# **Independent Review of Elemental Phosphorus Remediation at the Eastern Michaud Flats FMC Operable Unit near Pocatello, Idaho**

L.E. Martino,<sup>1</sup> J.J. Jerden, Jr.,<sup>2</sup> T.A. Kimmell,<sup>1</sup> and J. Quinn<sup>1</sup>

Work sponsored by U.S. Environmental Protection Agency

January 2016

**FIGURE 2-4 Plan View and Simplified Representation of P4 in the Subsurface (Source: FMC 2009, Figure 4-2)**

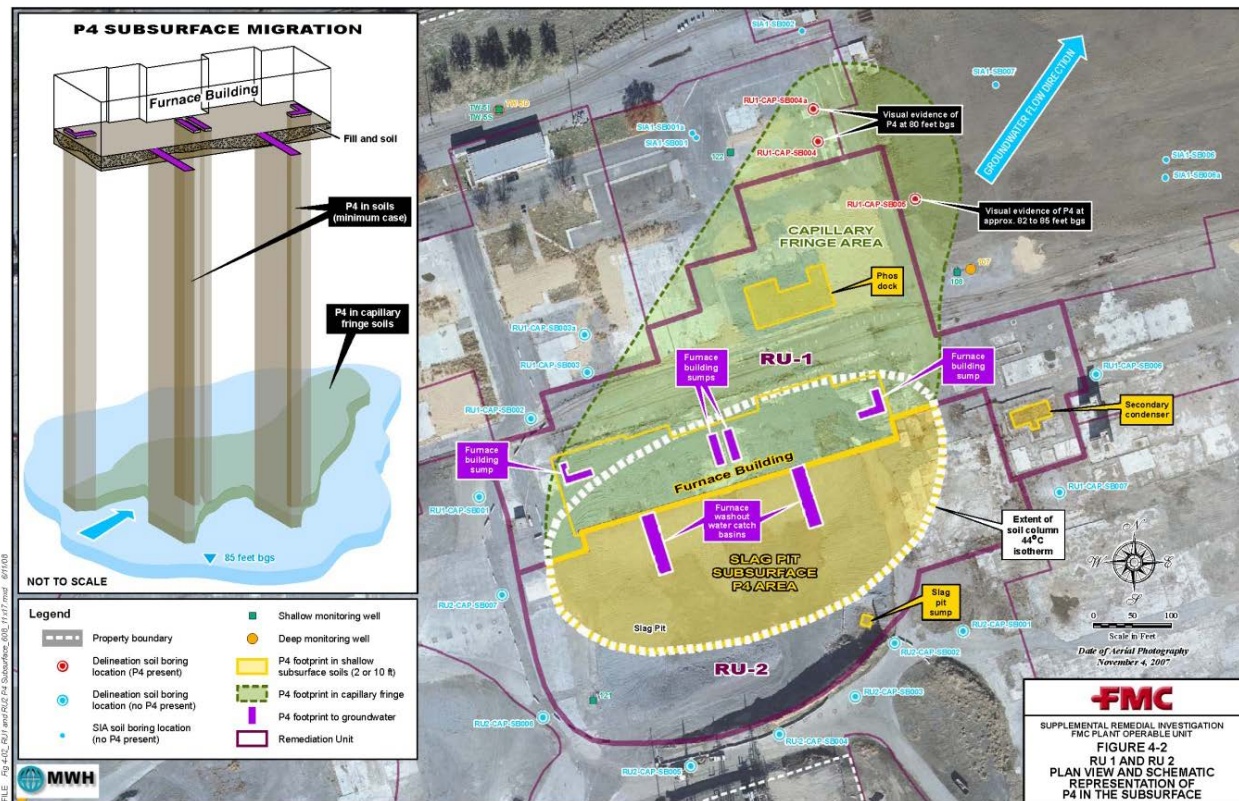
34	13	8	<p>Do we have a model estimate from previous reports?</p>	<p>The text in Pg. 13, Line 8, will be modified as follows after capillary fringe: <i>The 44°C isotherm was modeled by investigators (FMC 2009). Presumably, the depiction of P4 subsurface presence and migration in Figure 2-4 is based on that model.</i></p>
35	14	1	<p>The first two sentences are confusing and misleading. The Bevill amendment/exemption from RCRA regulation process wastes from the beneficiation of minerals and ores. The Bevill exemption for waste generated during the production of P4, except furnace off gas solids, ended on March 1, 1990. The exemption for furnace off gas solids ended on July 23, 1990. Upon the lifting of the Bevill exemption, beneficiation wastes that were hazardous waste were subject to RCRA regulation. Exempt wastes disposed of prior to the lifting of the Bevill exemption would not be subject to RCRA</p>	<p>Argonne agrees that the first two sentences of this paragraph may be misleading in light of the Bevill amendment and exemptions. This section has been rewritten to report that portions of the site are regulated under RCRA post-closure plans, and portions of the site are regulated CERCLA, as amended. A footnote is added at the end of the second sentence as follows:</p> <p><i>The former FMC plant is regulated under both RCRA, as amended, and CERCLA, as amended. P4 waste is present at the former FMC plant in waste disposal units that are being managed under RCRA post-closure plans. P4 waste is also present in portions of the plant that</i></p>

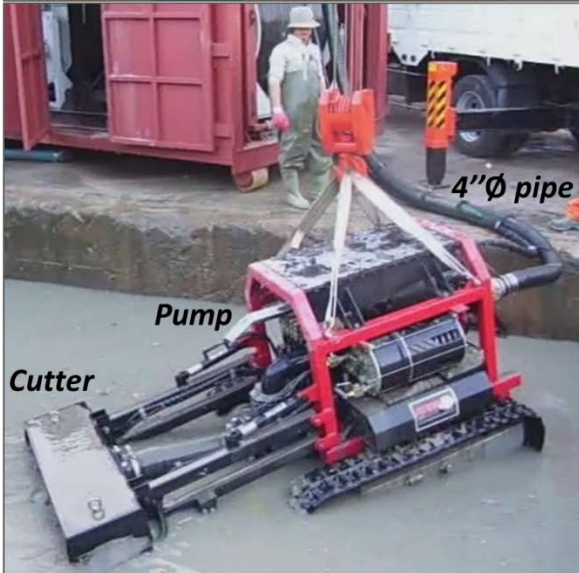
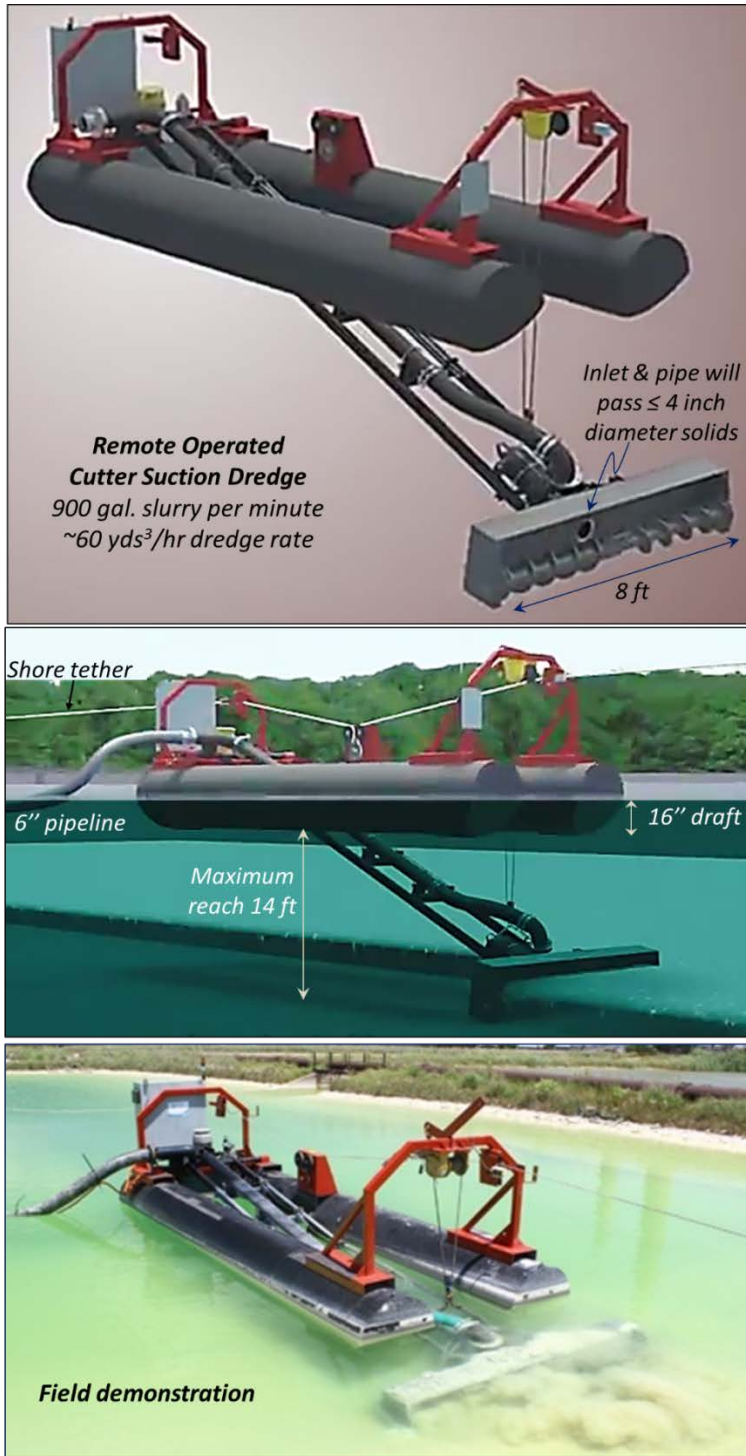
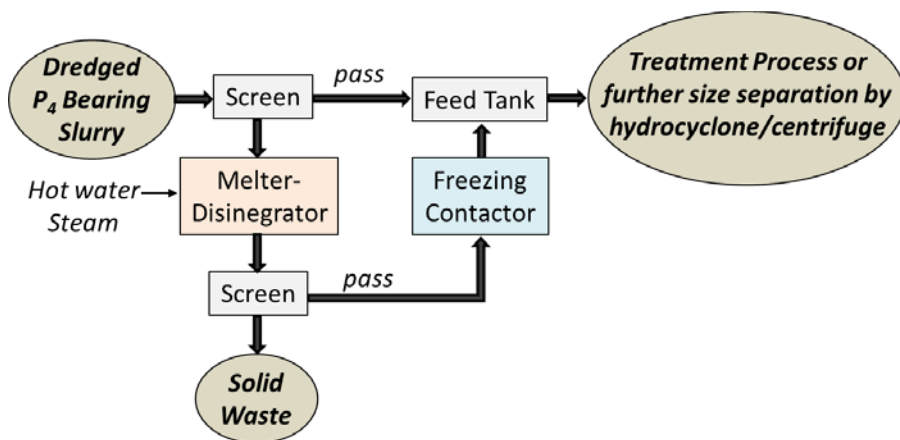
<b>SBT Comment Number</b>	<b>Tribes' Comment</b>	<b>Response by Argonne Review Team</b>
20	<p><u>Section 5.2.2</u> Mechanical Excavation Technologies</p> <p>Page 54 cites Figures 5-3 and 5-5 but they do not follow page 54. There is no information discussing ambient temperature below 44 degrees C and its effect on the excavation. If the excavation were done at cold temperatures, would the hazards and exposure be minimized?</p>	<p>Pg. 54, Line 1: A phrase will be added to the sentence as follows: ... <i>performing the excavation when ambient temperatures are below 30°C (or by controlling temperature in a temporary structure erected over the excavation site) and/or by keeping the white-phosphorus-bearing materials covered and saturated with water, while the off-gas from the excavation site could be captured and treated.</i></p> <p>Pg. 54, Line 4: The sentence will be modified to include a reference to the use of a temporary structure over the excavation site: The pyrophoric hazard could be mitigated by performing the excavation <i>when ambient temperatures are below 30°C (or by controlling temperature in a temporary structure erected over the excavation site) and/or by keeping the white-phosphorus-bearing materials...</i></p>

FIGURE 5-15 RUs Identified as Containing Underground Piping, Sumps, and Structures (Source: FMC 2009)

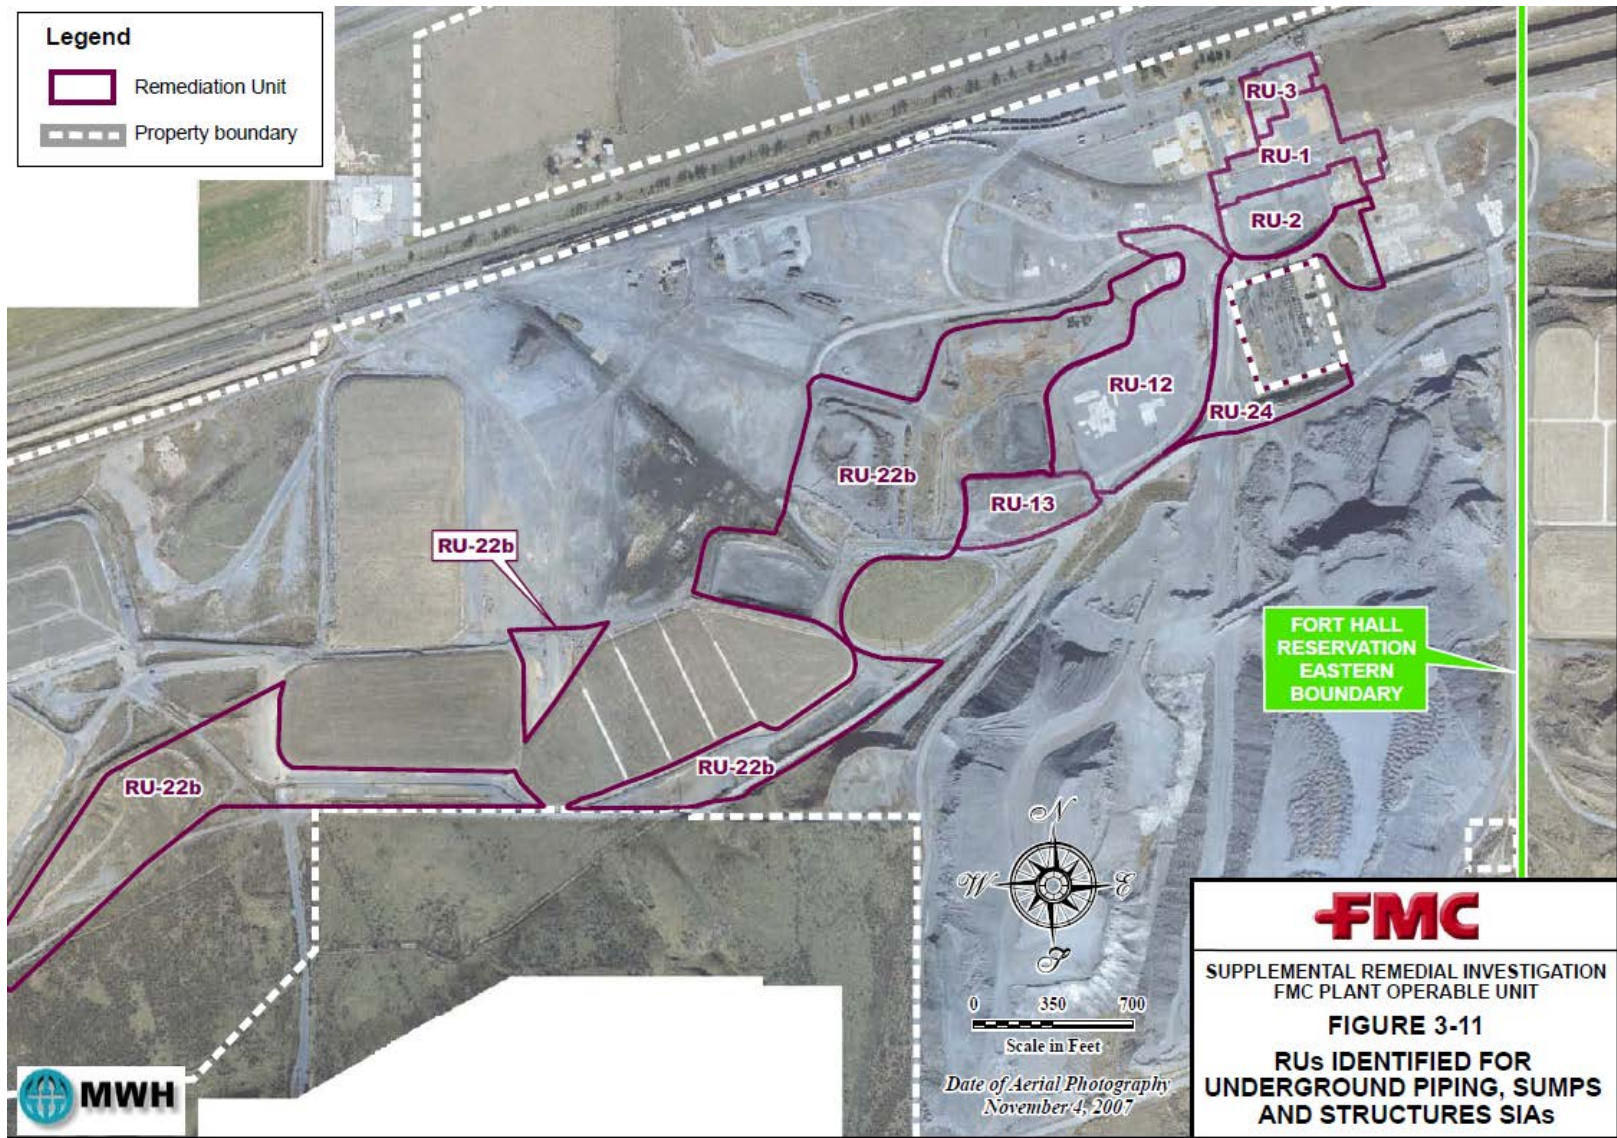
87	105	35	Note that the SFS includes a Section 7 figure (Figure 7-2). For what was the IRODA selected remedy that indicates pipes suspected (based on process knowledge) to contain P4 that would be cleaned.	Comment noted. The figure used also depicts the RUs where pipelines are suspected to be present.
88	115	15	“Guzzler” could use a reference.	Guzzler™ was referenced in a previous section of the report.
89	122	4	Excavation technologies also have a similar limitation regarding insufficient characterization (i.e., one cannot just start digging up a site without a level of confidence in knowing the state and location of contamination). Ex situ treatment technologies may share in this limitation, noting that incineration may have a greater degree of	This section is discussing in situ treatment technologies that could potentially target areas not accessible with excavation technologies. As it happens, P4 present in the deep subsurface is not characterized at all. In contrast, much more is known about the contents of the historical ponds that could be targeted with excavation technologies. This is due to process knowledge and the fact that some samples have been collected from the historical ponds (EPA 2003).
